**ADDENDUM #2**

Project: Riverside Middle School and Whiteknact Elementary School Secure Entrances  
East Providence, RI

Project Number: 1KCT00164.000

NUMBER  
 SK-A1.0

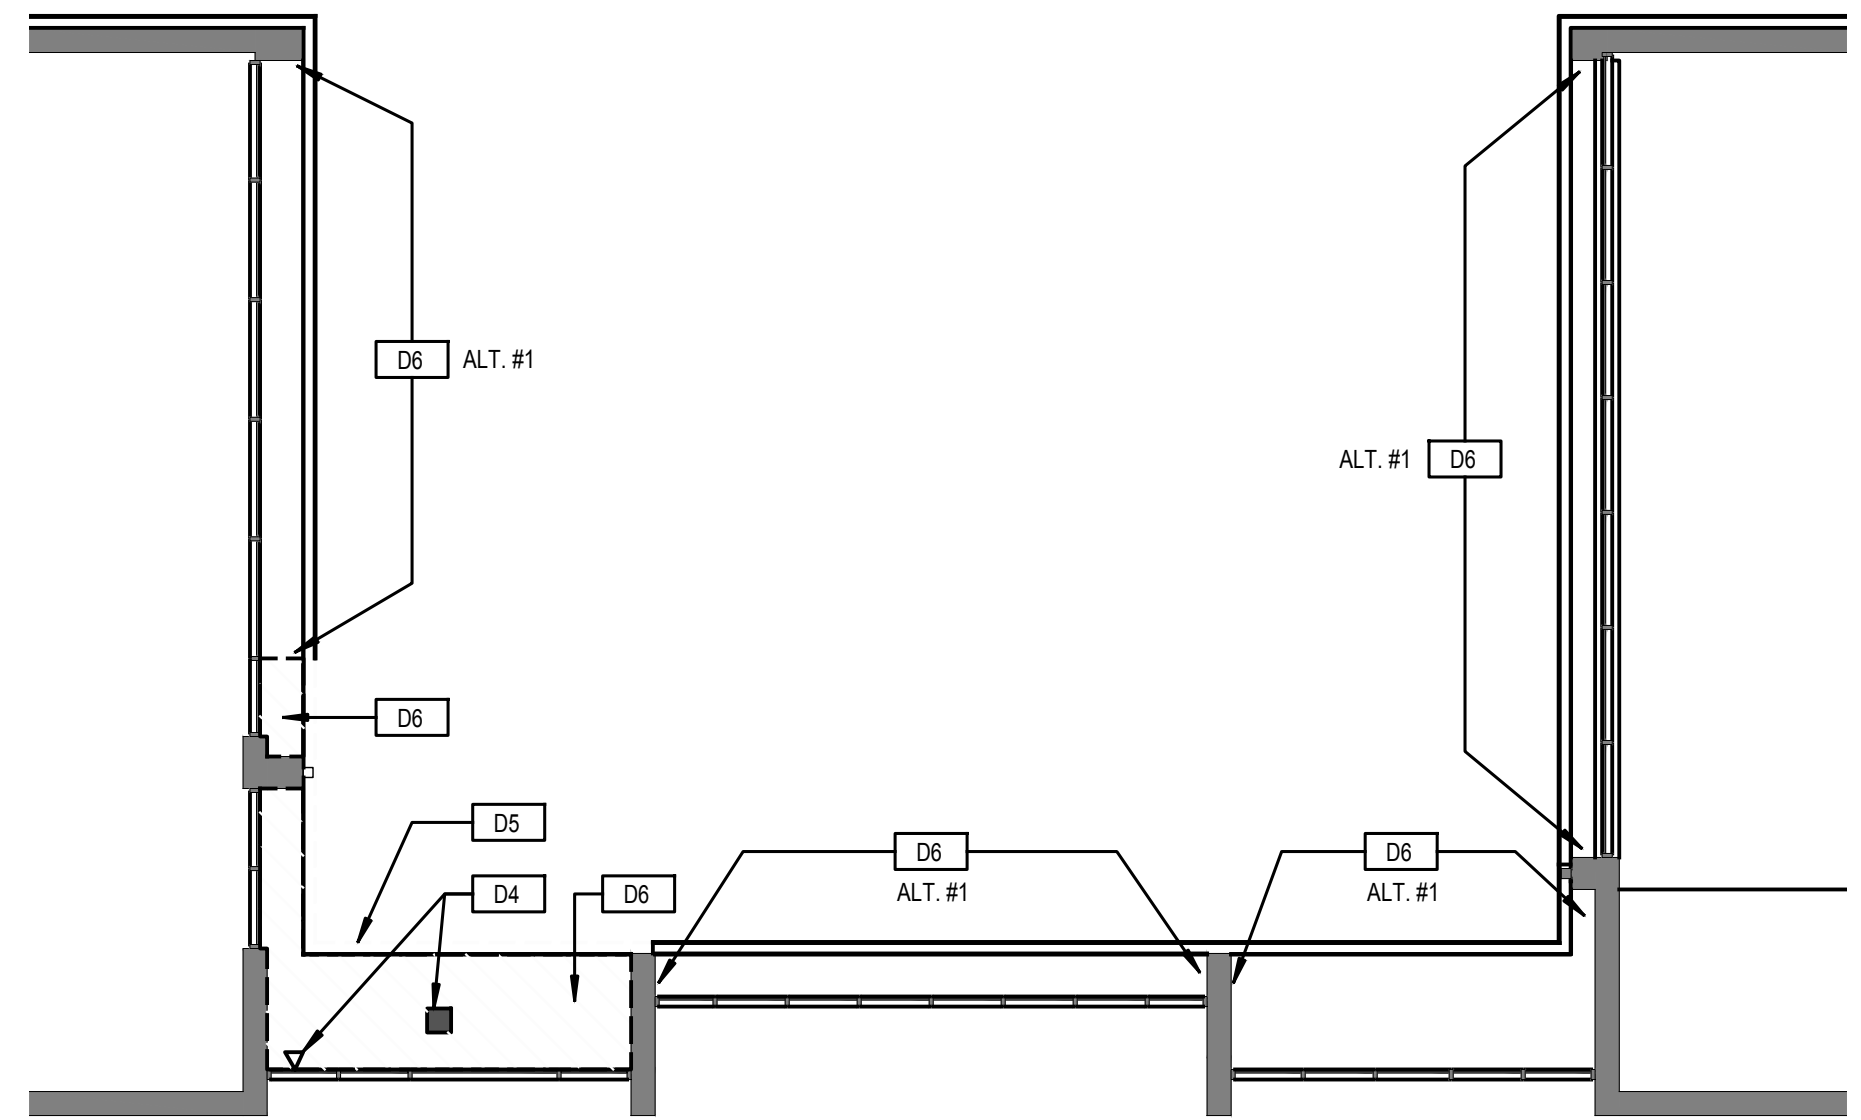
- 9) *Studio JAED*: A sketch, SK-A1.0, has been provided indicating scope for Add Alternate #1, included in this addendum. Add Alternate #1 has also been provided on the revised Bid Form provided in this addendum.

**D7** CONTRACTOR TO PROVIDE AN ADD ALTERNATE COST FOR ADDITIONAL ACM SOFFIT DEMOLITION AS INDICATED IN THE ATTACHED DRAWING. CONTRACTOR TO FURNISH AND INSTALL NEW METAL SOFFIT MATERIAL AND SHEET METAL ROOF EDGE CONNECTION AS WELL AS COLD FORM METAL FURRING FOR ATTACHMENT AS NECESSARY. EXISTING GUTTER MAY REQUIRE TO BE REMOVED AND REINSTALLED TO FACILITATE THE WORK. SOFFIT IS NOT REQUIRED TO BE VENTED

NUMBER  
**SK-FP1.0**

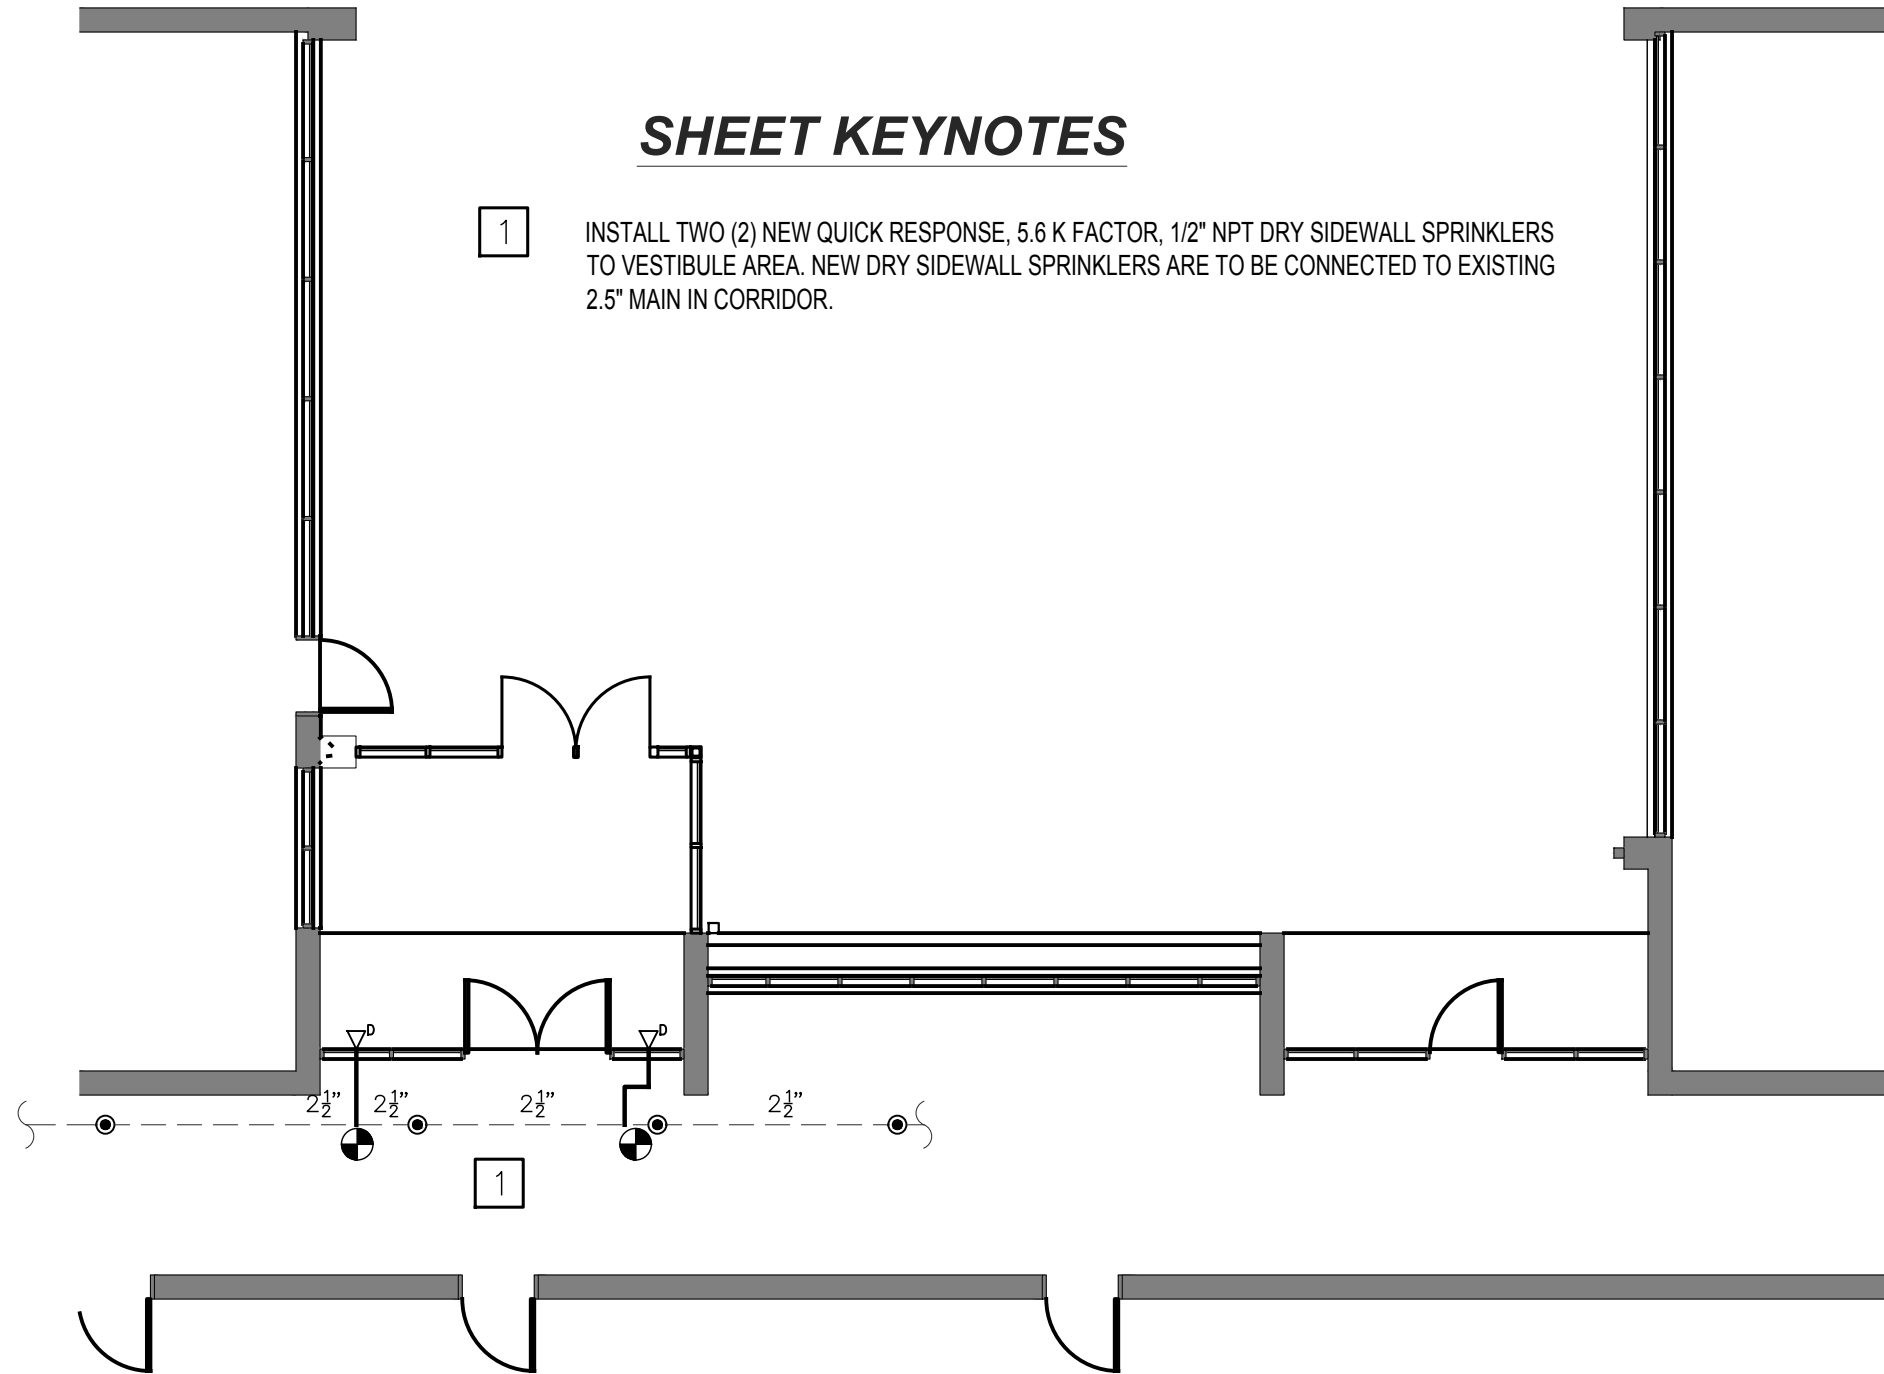
- 6) *Jensen Hughes*: The roof at Whiteknact Elementary School was installed by Capeway Roofing Systems and is under warranty.
- 7) *Jensen Hughes*: A sketch, SK-FP1.0, has been provided as part of this addendum for the fire protection scope of work.

- 1 INSTALL TWO (2) NEW QUICK RESPONSE, 5.6 K FACTOR, 1/2" NPT DRY SIDEWALL SPRINKLERS TO VESTIBULE AREA. NEW DRY SIDEWALL SPRINKLERS ARE TO BE CONNECTED TO EXISTING 2.5" MAIN IN CORRIDOR.
